PUBLIC IMPROVEMENT CONSTRUCTION PLANS
THE BRICKYARD - PRAIRIE HAWK INFRASTRUCTURE
A PARCEL OF LAND BEING A PORTION OF THE NORTHEAST 1/4 OF SECTION 10 AND THE NORTHWEST 1/4 OF SECTION 11 TOWNSHIP 8 SOUTH, RANGE 67 WEST OF THE 6TH P.M. TOWN OF CASTLE ROCK, COUNTY OF DOUGLAS, STATE OF COLORADO.
TOWN OF CASTLE ROCK PROJECT NO. CD25-0042

KEY MAP

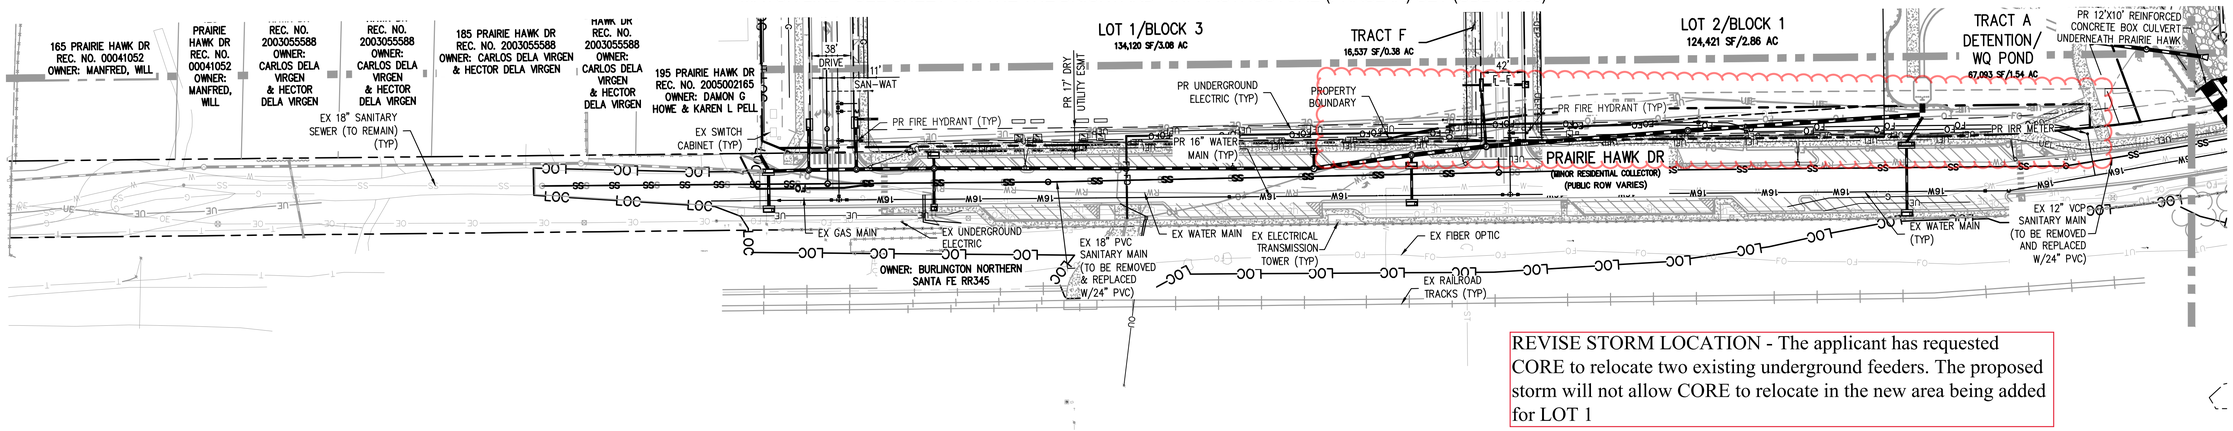
REVISE STORM LOCATION - The applicant has requested CORE to relocate two existing underground feeders. The proposed storm will not allow CORE to relocate in the new area being added for LOT 1

EXISTING PRAIRIE HAWK PLAN

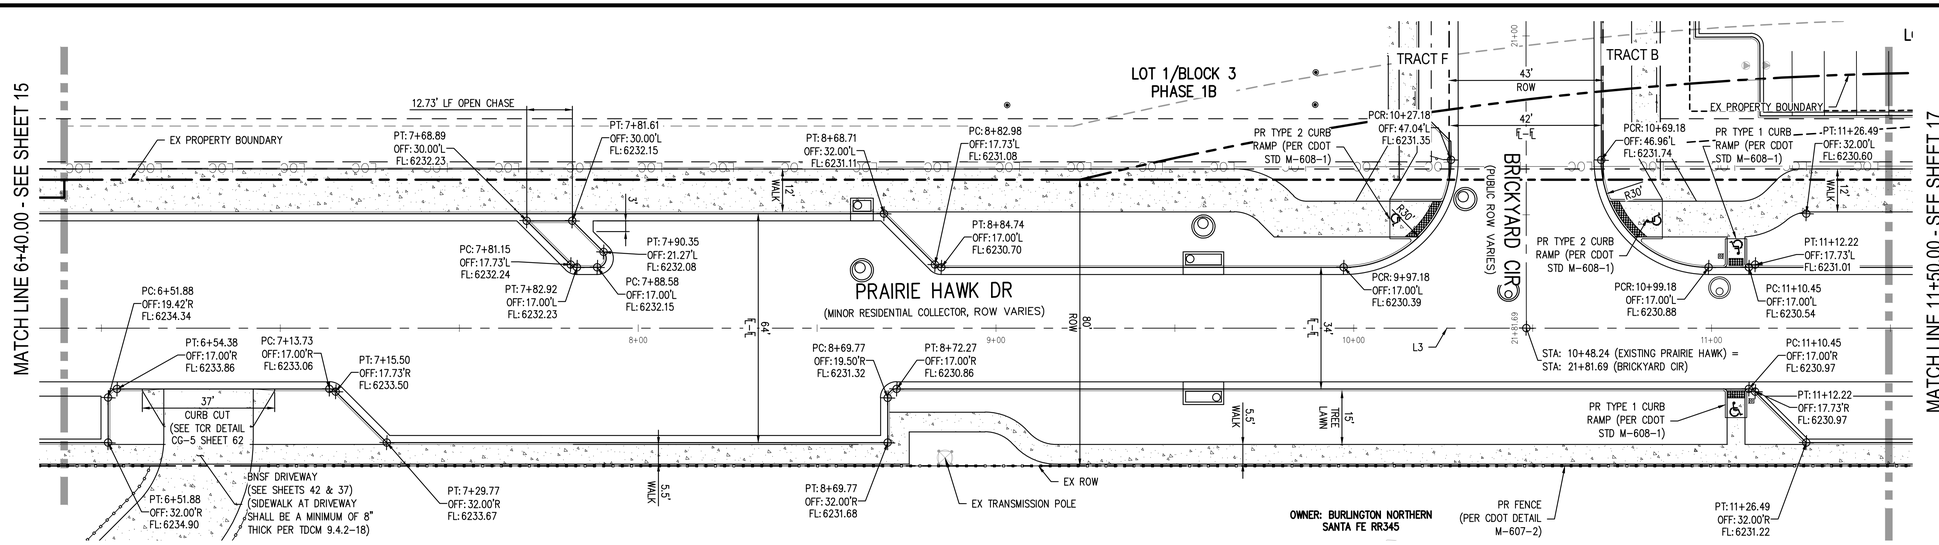
MISSING STREET LIGHT LOCATIONS

EXISTING PRAIRIE HAWK PLAN

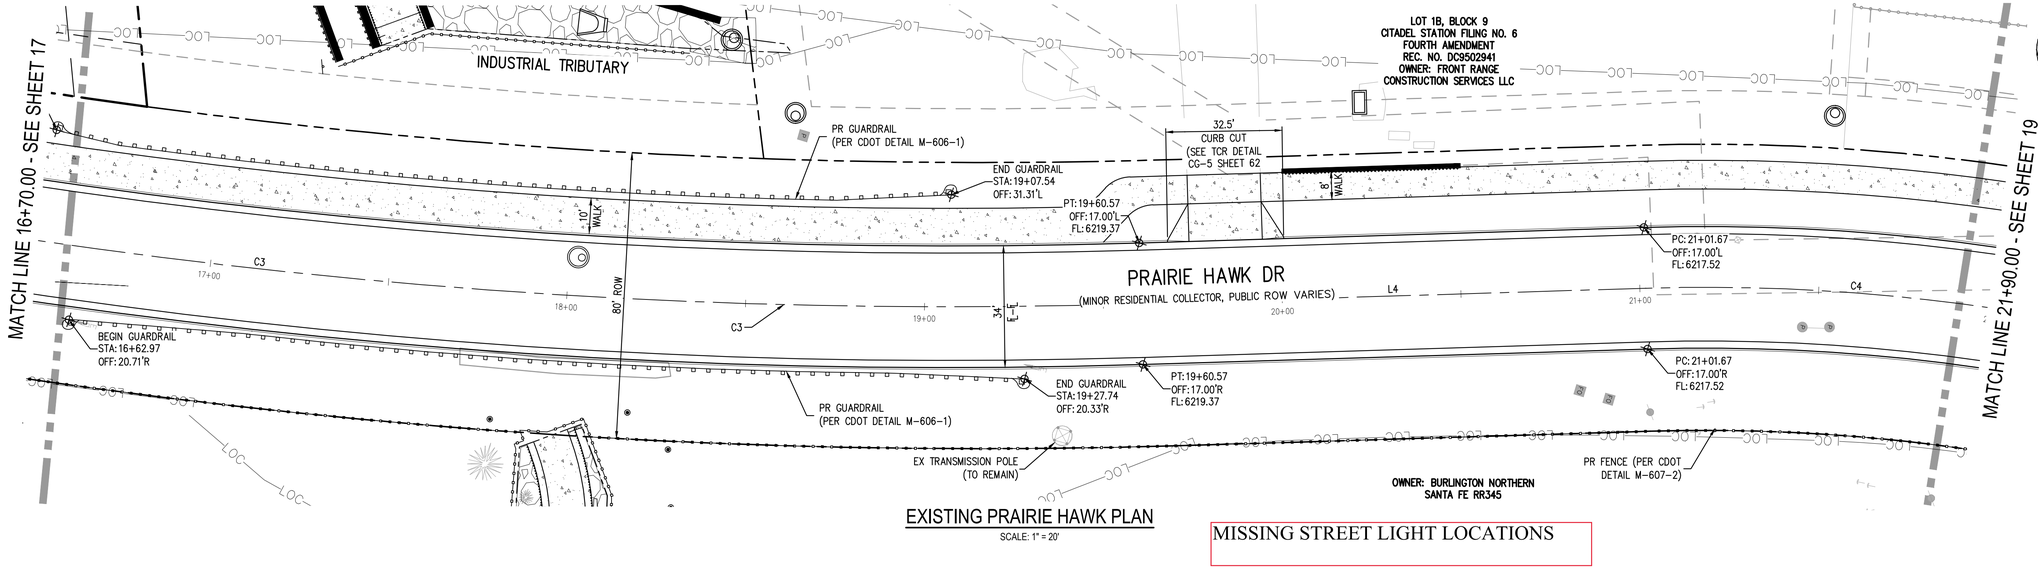
MISSING STREET LIGHT LOCATIONS

1 OVERALL LANDSCAPE PLAN

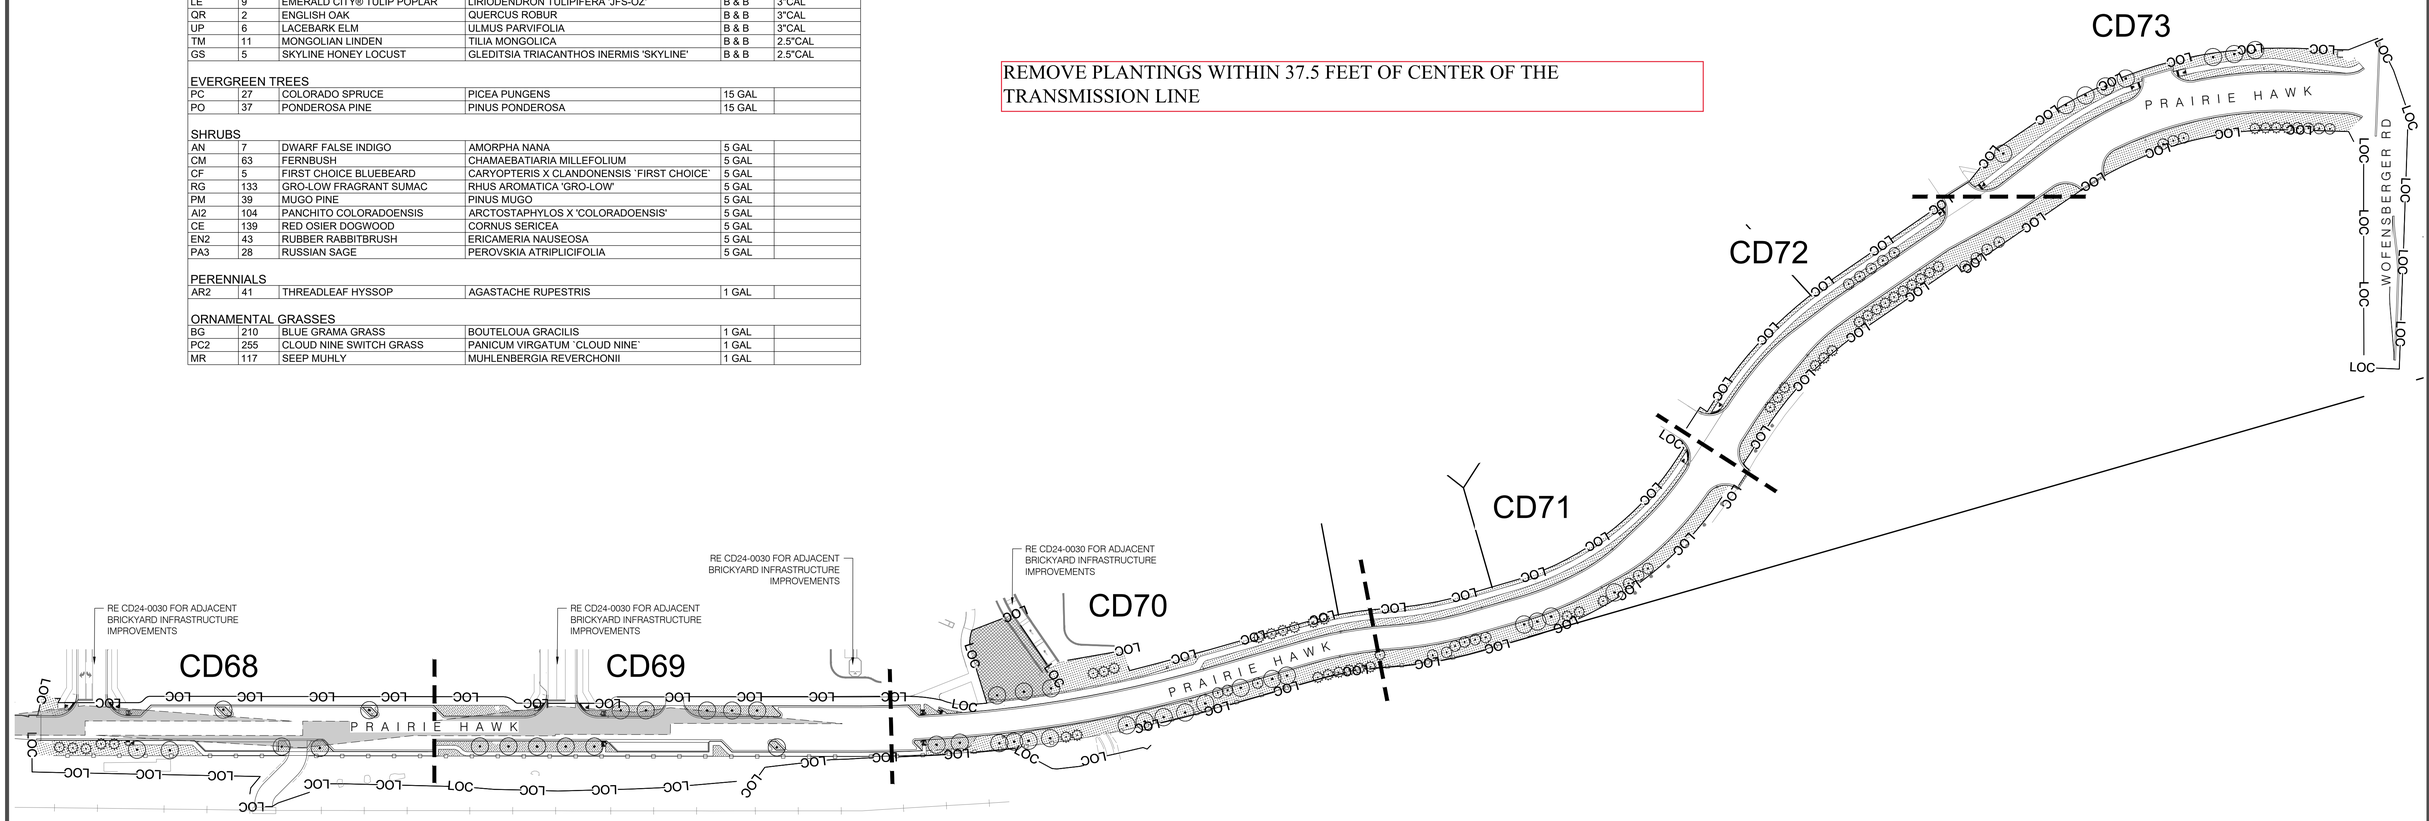
REMOVE PLANTINGS WITHIN 37.5 FEET OF CENTER OF THE TRANSMISSION LINE

1 LANDSCAPE ENLARGEMENT PLAN

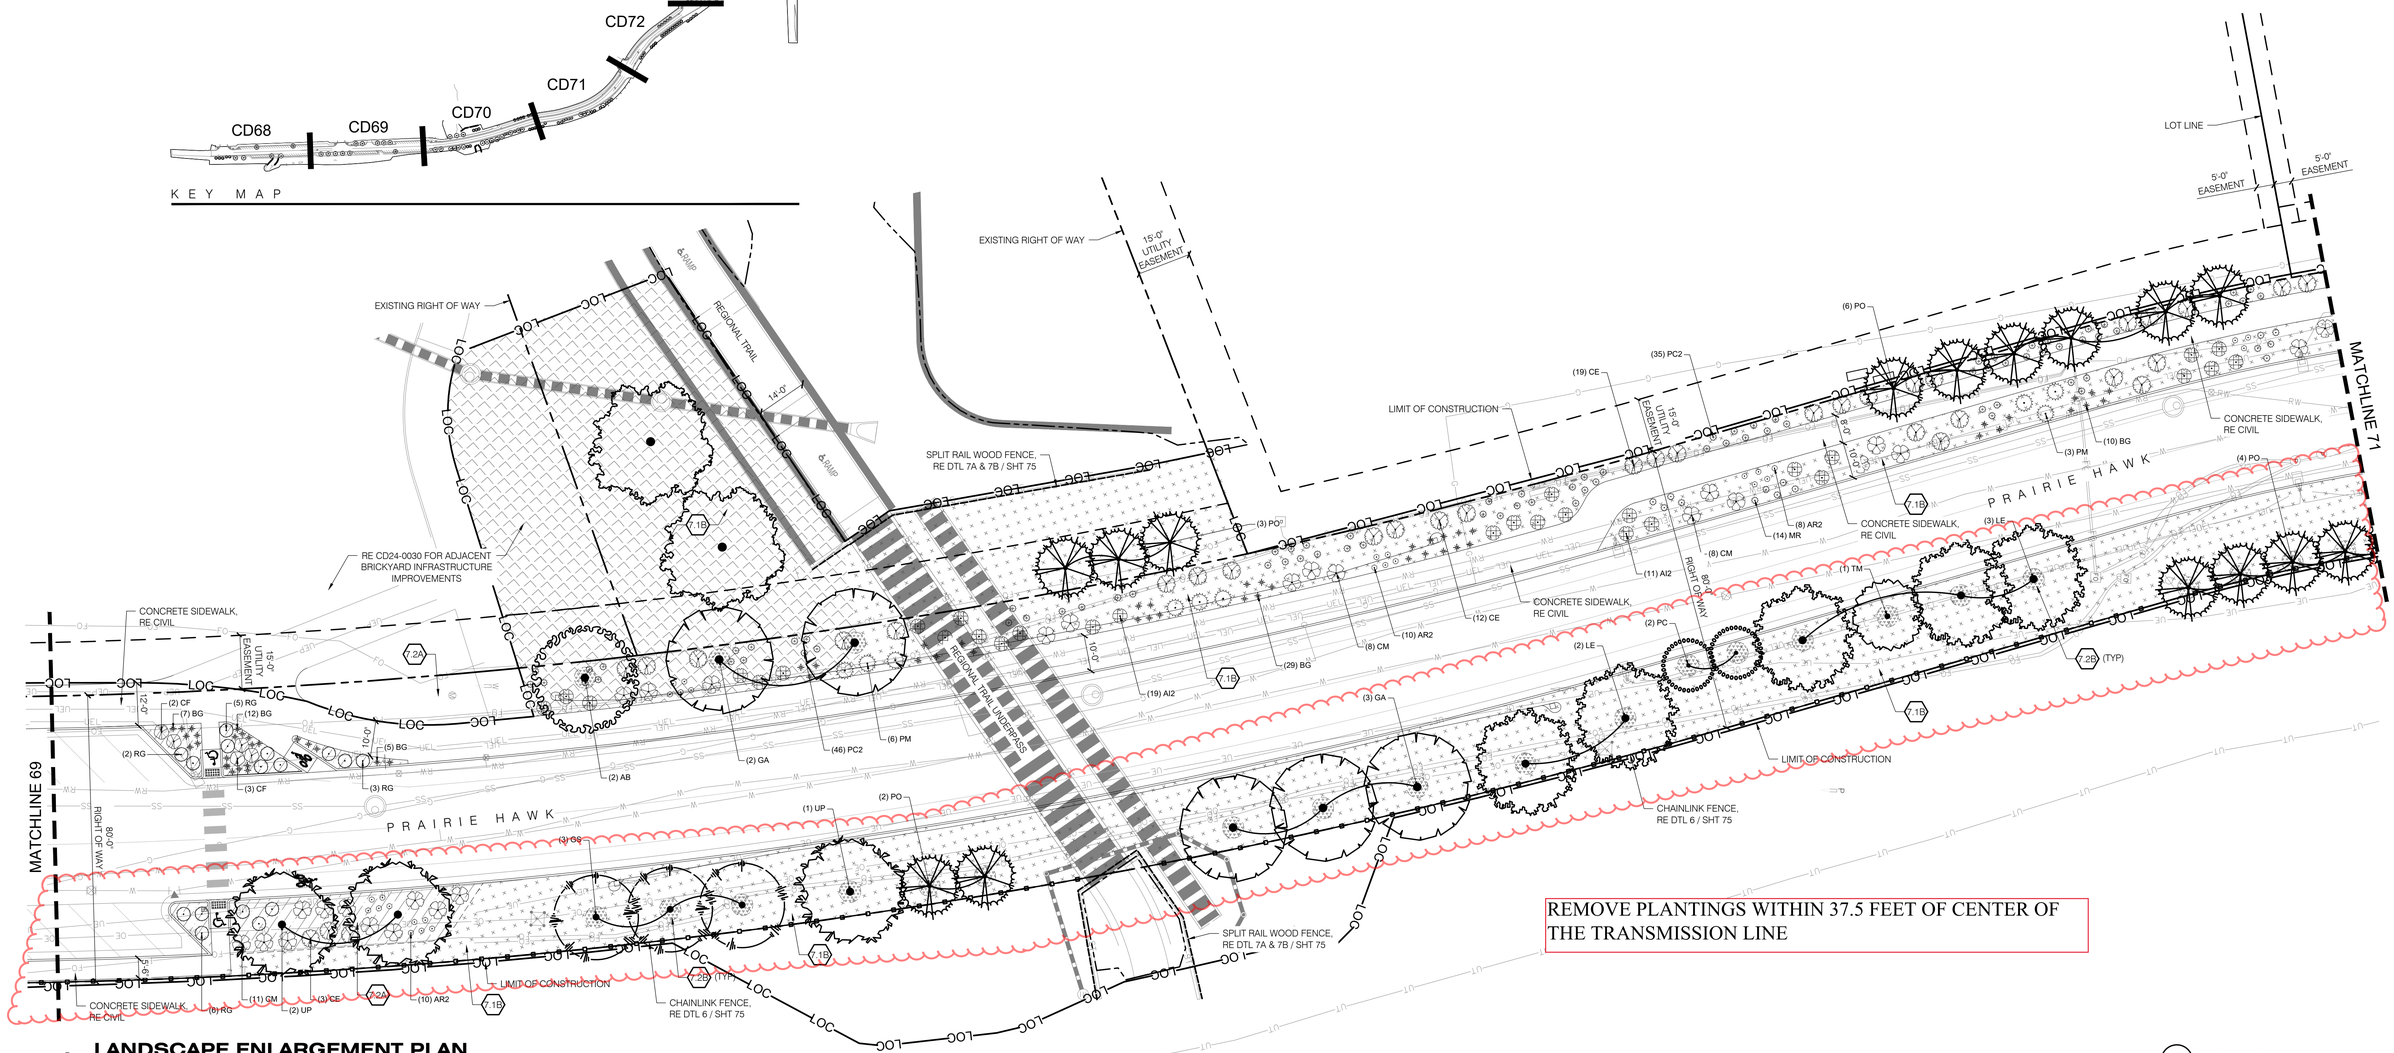
REMOVE PLANTINGS WITHIN 37.5 FEET OF CENTER OF THE TRANSMISSION LINE

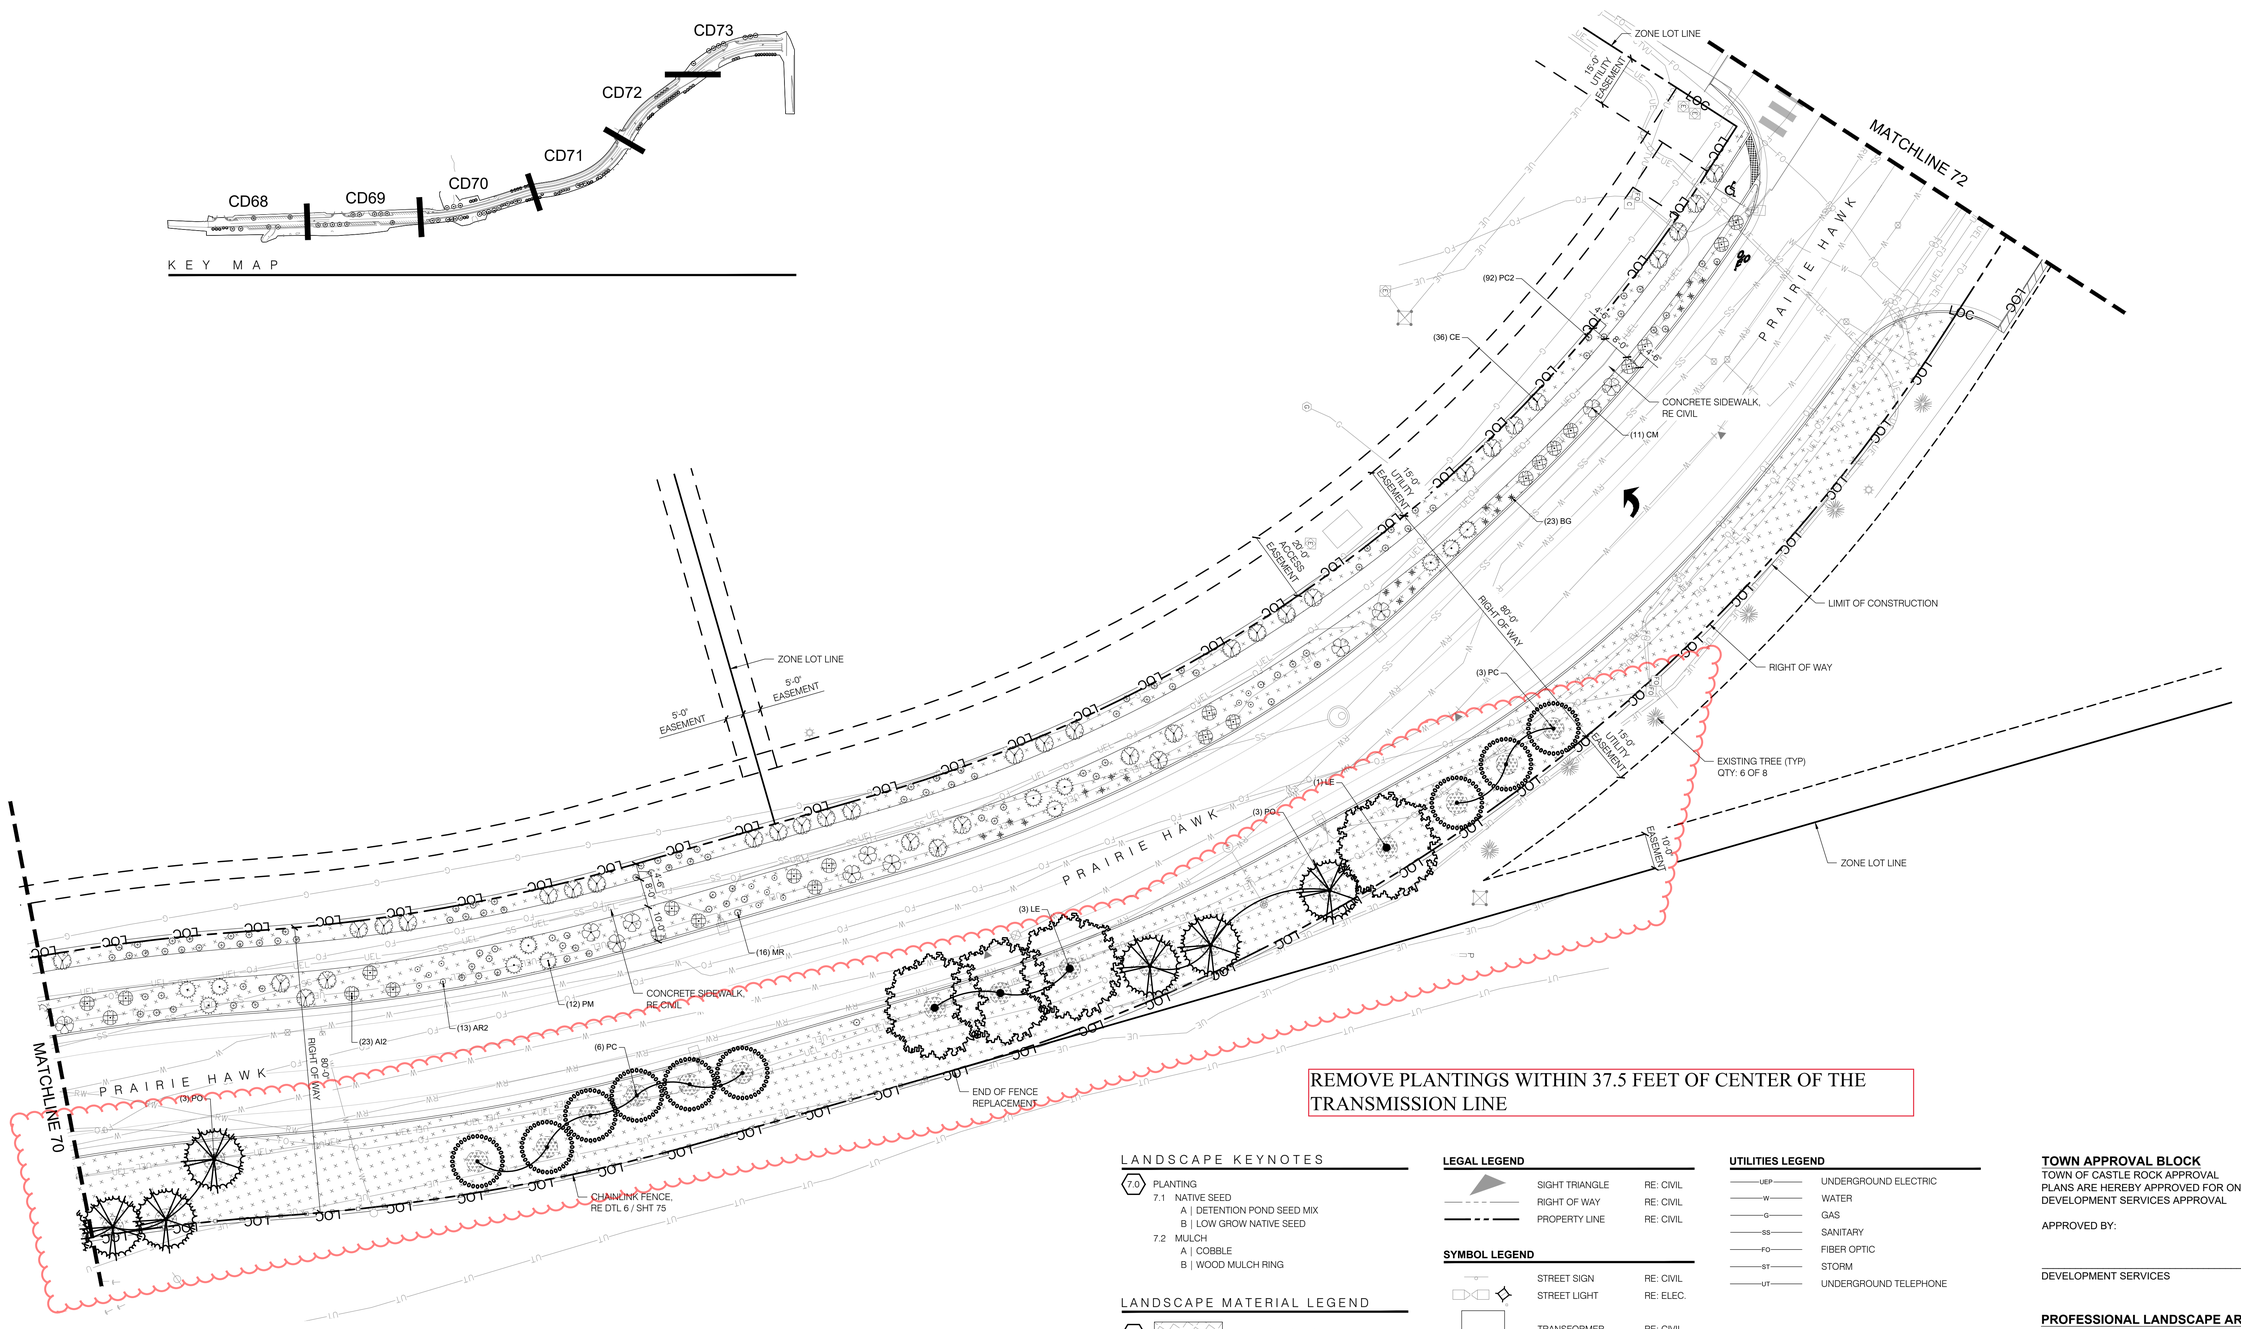
REMOVE PLANTINGS WITHIN 37.5 FEET OF CENTER OF THE TRANSMISSION LINE
